Re: Objection to (Amended) DA2024/0453 – 13 Knight Street, Warriewood

We have reviewed the amended plans and documents as part of the application in question and present this submission to outline the reasons for objection to DA2024/0453 for *Construction of a dwelling house* at 13 Knight Street, Warriewood (Lot 13 DP270922).

Figure 1 (above): Windows on northern facade overlooking 23 & 25 Cherry Lane.

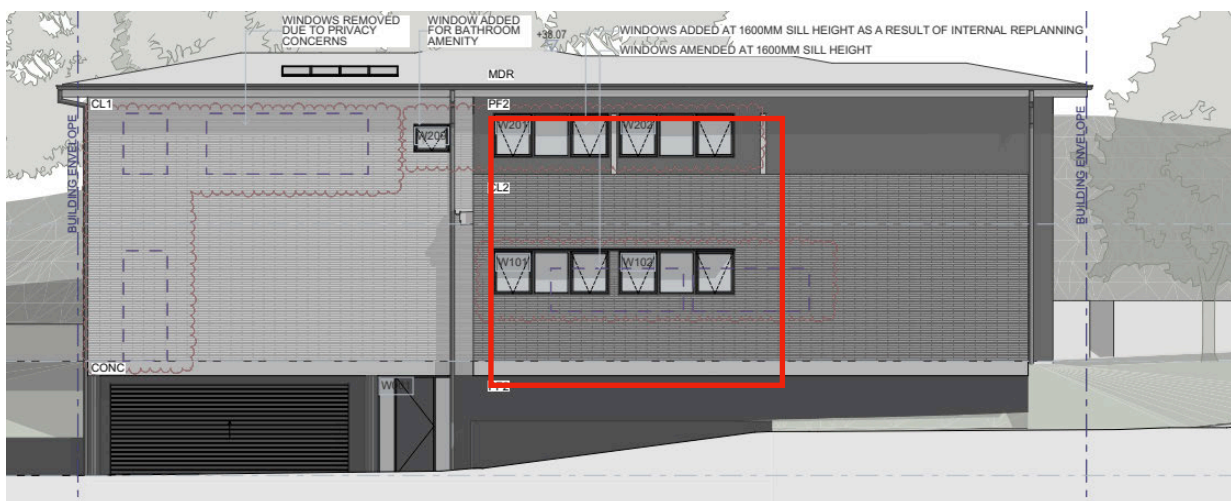
At 25 Cherry Lane our existing alfresco area and adjacent living and dining area will be directly overlooked by the elevated windows and alfresco area of the proposed dwelling (See Figure 1). This is unacceptable as it intrudes on the existing privacy and amenity of 25 Cherry Lane.

We request the Council reassess the proposal in light of the aforementioned privacy issues and consider necessary amendments to enhance neighbour privacy and overlooking protections to Cherry Lane properties. Additionally, for the same reasons as outlined above we express concerns regarding kitchen and bedroom windows and request the installation of privacy screens (as a minimum) to address these issues.
